PLANNING AND ZONING DIVISION

FILE NUMBER: Z0223-0291
REQUEST FOR: Rezoning from Traditional Neighborhood Mixed Residential and R-3 Single Family Residential to Planned Development – Multifamily
CASE MANAGER: Garrett Langford, AICP

Applicant: Horrocks Engineers, on behalf of Helu Development
Requested Action: Comprehensive Plan Amendment from Medium Density Residential to High Density Residential and a Zoning Change from Traditional Neighborhood Mixed Residential and R-3 Single Family Residential to Planned Development – Multifamily to allow a 240-unit apartment complex with modifications.
Location: 1400 and 1609 Range Drive

ATTACHMENT 11 – REVISED CONCEPT PLAN (EXHIBIT C)

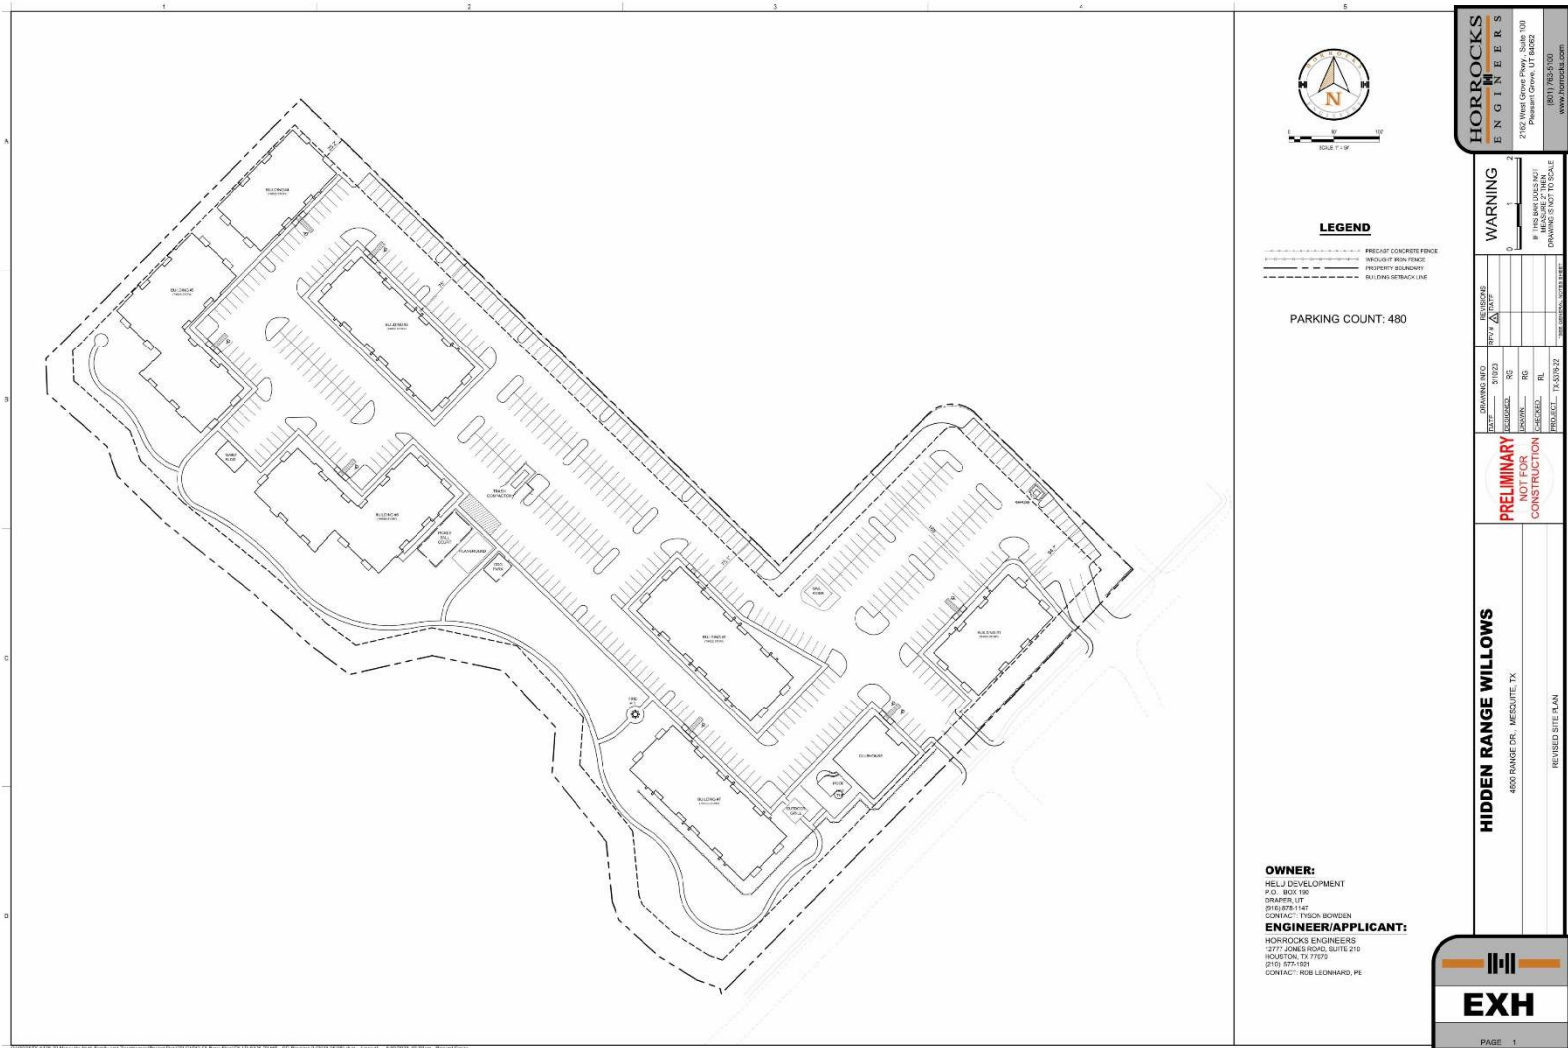
UPDATE – On May 1, 2023, City Council unanimously postponed the request to allow the applicant to revise their Concept Plan to address concerns regarding parking and amenities. On May 10, 2023, the applicant provided a new concept plan with the following changes, as summarized by the applicant.

1. By making all buildings three stories, we were able to revise the site plan to accommodate the required 2:1 parking ratio required by the multi-family zoning code.

2. We removed one building from the center of the site and added parking, so the remaining buildings (Buildings 2 and 3) are now further away from the alley loaded patio homes.

3. We moved Building 1 (1609 Range Drive) toward Range Drive by over 120 feet, so it is now 185 feet from the patio homes. Also, there is no longer parking between Building 1 and Range Drive, now following the associated code requirement.

4. We clustered the amenities by moving the pickleball court from its original location immediately adjacent to Range Drive to the center portion of the site along with other outdoor amenities. We still have other indoor/outdoor amenities clustered near the clubhouse.

5. We removed five refuse containers from the site, two that were within 100 feet of the patio homes and added a centralized trash compactor/recycle area in the center of the site.

Attachment 11 includes the concept plan. Staff has reviewed the concept plan based upon the supplementary development standards for multifamily in Section 2-501 of the Mesquite Zoning Ordinance and the proposed PD development standards. Staff finds that all requirements are being met, except identified in the following section.

Staff Comment: (Updated) To make room for more parking, the applicant reduced the number of buildings from eight to seven. Additionally, the four buildings located within 200 feet of the residential development to the northeast were raised from two stories to three stories.

Staff Comment: The proposed development requires 2.2 acres of open space. To achieve this requirement, the applicant is installing a hiking trail within the floodplain/drainage way area.

Staff Comment: The development requires four from Group A and Group B for a total of eight amenities. The applicant has rearranged the outdoor amenities to a more centralized location as shown on the revised concept plan. The applicant is proposing the following:

Staff Comment: The proposed concept plan shows that the development will meet the required landscaping requirements.
